CABINET MEMBER FOR ENVIRONMENT – 7 SEPTEMBER 2017

PROPOSED SPEED LIMIT REDUCTIONS ON LINK ROADS TO A423 OXFORD SOUTHERN BYPASS

Report by Director for Infrastructure Delivery

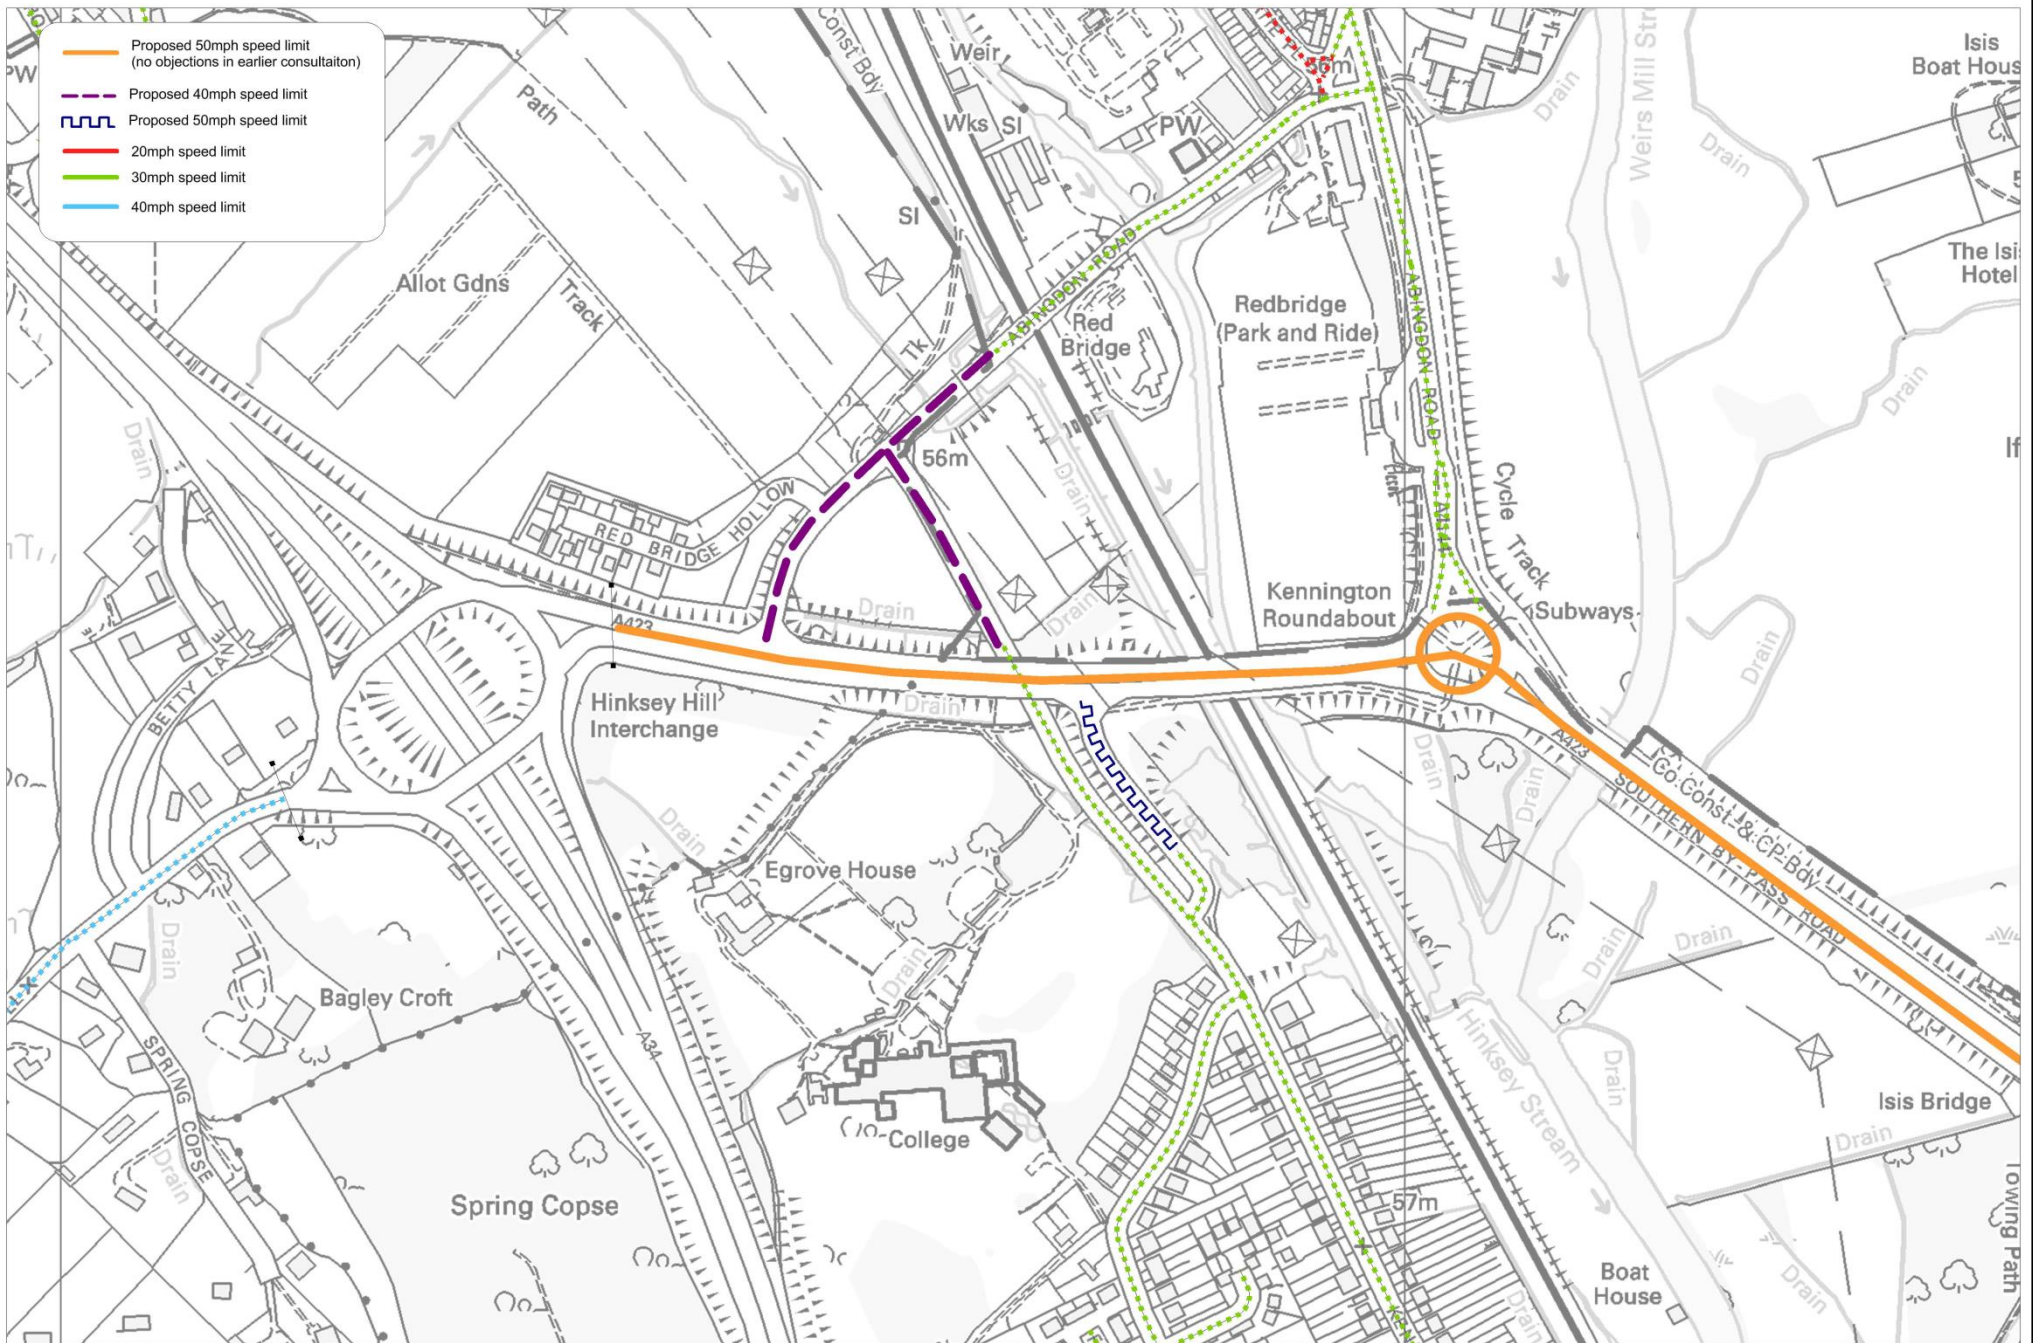
RESPONDENT	SUMMARISED COMMENTS
(1) Thames Valley Police	No objection - On a point of consistency I am slightly confused that the speed limit on the roads north of A423 will be subject to a 40 mph whereas the slips road on the south side (a much shorter road) will be subject to a 50 limit.

(2) Kennington Parish Council	Neither – but noted the view that the proposed 40mph speed limit change may be confusing for drivers, and the council suggested that this is changed to 30mph.

(3) Vale of White Horse District Council	No objection.
(4) Cyclox & Cycling UK	<p><u>40mph Speed Limit on Kennington Road</u> – Object – This stretch of road is designated a "Cycle Super Route" in LTP 4. While works beyond the scope of this consultation are needed to achieve Super Route specification, lowering the speed limit to 30 mph would make the road environment more cycle friendly. Whilst the proposals as advertised MAY have some beneficial effect, Cyclox and Cycling UK object to what we see as 'interim' limits between speed regimes and call for 30 mph. It is a change that would be a best fit with LTP4 objectives. Indeed, looking at the accident data for this road between Kennington Road and Bertie Place, a 20 limit would be a change that would be a best fit with LTP4 objectives.</p> <p><u>40mph Speed Limit on Northern slip road</u> – Object – This stretch of road is designated a "Cycle Super Route" in LTP 4. Some of this road has a substandard cycle track, and some of this road has no on/off road cycle provision at all. While works beyond the scope of this consultation are needed to achieve Super Route specification, lowering the speed limit to 30 mph would make the road environment more cycle friendly. Whilst the proposals as advertised MAY have some beneficial effect, Cyclox and Cycling UK object to what we see as 'interim' limits between speed regimes and call for 30 mph. It is a change that would be a best fit with LTP4 objectives..</p> <p><u>50mph Speed Limit on Southern slip road</u> – Object – This stretch of road forms an important link between 2 "Cycle Super Routes" in LTP 4 (linking Kennington Road with the A 423 cycle track to Kennington and Heyford Hill roundabouts). While works beyond the scope of this consultation are needed to achieve Super Route specification,</p>

<p>lowering the speed limit to 30 mph would make the road environment more cycle friendly, noting that the slip road slip road is used by cyclists top access the well used segregated cycle track by the A 423 (which is a good link to southern and eastern Oxford employment areas). This requires crossing the slip road at the top just as vehicles exit the A 423. There is no central refuge to use, and some vehicles exit the A 423 quite fast. With this in mind, a 50 mph limit is unacceptable. It would be more appropriate to extend the 30 limit all the way up to the top of the slip road (and move the "Kennington" village sign to the top of the slip road as a reinforcement). Whilst the proposals as advertised MAY have some beneficial effect, Cyclox and Cycling UK object to what we see as 'interim' limits between speed regimes and call for 30 mph. It is a change that would be a best fit with LTP4 objectives..</p>

<p>(5) Online response, (unknown)</p>	<p><u>40mph Speed Limit on Kennington Road</u> – Object – I believe the proposed changes in speed limits are potentially confusing and the opportunity should be taken to simplify them. I believe the proposed 40mph section should be 30mph with the exception of the northern and southern slips (eg from A423 to before Red Bridge Hollow, and Kennington Road to A423). I would also like to see the priority changed or the installation of a mini-roundabout to improve the junction between Kennington Road and Old Abingdon Road with traffic travelling east on Old Abingdon Road giving way. At present Old Abingdon Way is used as a rat run for traffic from the A34 to the city centre south..</p> <p><u>40mph Speed Limit on Northern slip road</u> – Object – Should be 50mph reducing to 30 (see above).</p> <p><u>50mph Speed Limit on Southern slip road</u> - Support – <i>No comment.</i></p>

9. The response of Thames Valley Police is noted. The current proposals were drawn up following consideration of the police objection to the proposed introduction of a 30mph speed limit on these roads on the grounds that their character was not consistent with the Department for Transport (DfT) guidance on setting local speed limits. Officers considered alternative options taking account of the DfT guidance, as discussed below.

10. On the roads to the north of the A423 bypass, the options considered were either the introduction of a 40mph or 50mph speed limit; the former was considered more appropriate taking account of the character of the road and the presence of some accesses, including that for Red Bridge Hollow. The proposed 40mph speed limit will require signs not only at the terminal points, but also repeater signs along these roads, which should address the concerns raised by Kennington Parish Council on possible confusion for drivers. Indeed one advantage of the current proposal in this respect as compared to the previous proposal for a 30mph speed limit is that the latter would have resulted in there only being 30mph signs at the A423 junction, as national regulations on speed limit signing prohibit the use of 30mph repeater signs or carriageway roundels on roads - as here - with street lighting. There would therefore have been a potential risk that if drivers failed to see the 30mph signs on turning off the A423, they might mistakenly proceed on both the Old Abingdon Road and Kennington Road assuming the 50mph speed limit (which has been approved but yet to be implemented on the A423) still applied.

11. On the link road to the south of the A423, the only alternative option to extending the 30mph speed limit to the A423 junction (which was not supported by the police in the previous consultation) is to extend the 50mph speed limit on the bypass to meet the current 30mph speed limit, given that

the affected length of the link road is only 150 metres, and so is too short to have a separate speed limit.

12. The suggestion of CycloX/Cycling UK that a 20mph speed limit is considered on the Old Abingdon Road between the Kennington Road and Bertie Place junctions is noted, but is not considered to be consistent with DfT guidance on setting local speed limits.

15. **The Cabinet Member for Environment is RECOMMENDED to approve the proposals as advertised.**
